SUBJECT: BEAVER VALLEY POWER STATION, UNIT NO. 2 - SUMMARY OF  
CONFERENCE CALL REGARDING THE SPRING 2011 STEAM GENERATOR  
TUBE INSPECTION RESULTS (TAC NO. ME5882)

SUMMARY OF CONFERENCE CALL

REGARDING THE SPRING 2011 STEAM GENERATOR TUBE INSPECTION RESULTS

BEAVER VALLEY POWER STATION, UNIT NO. 2

Long term trending of circumferential ODSCC at TTS flaw parameters shows little change. The following plots present the circ ODSCC arc length and +Pt voltage distributions for the last three outages.

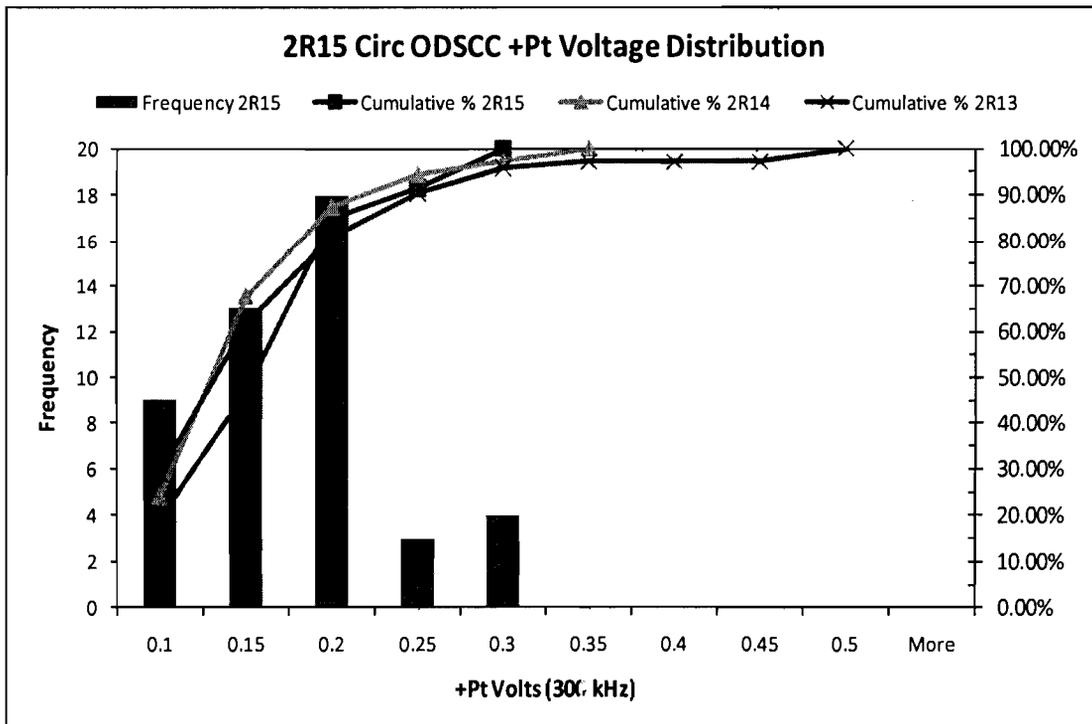
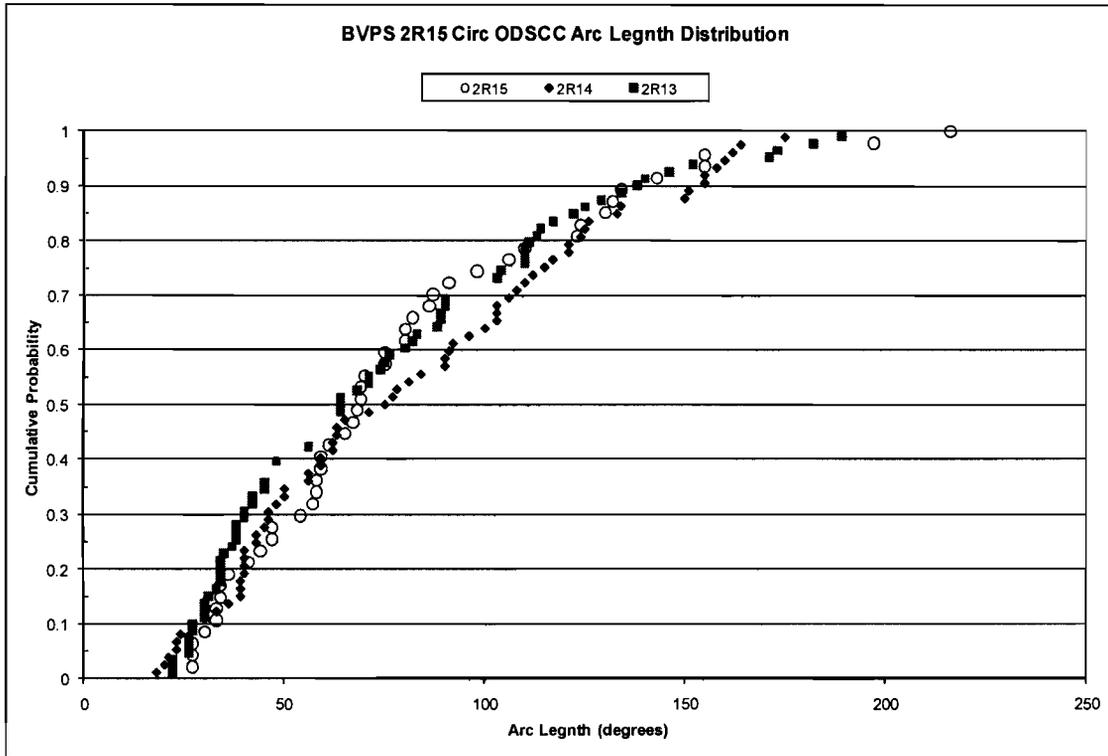
Circ ODSCC:

Length: 20 to 267 degrees arc, average of 84 degrees arc (first pass). The 267 degree arc indication was found to be comprised of two shorter cracks with non-degraded ligaments between the cracks from profiling.

Voltage: 0.06 to 0.29 volt, average of 0.15 volt, in 300 kHz
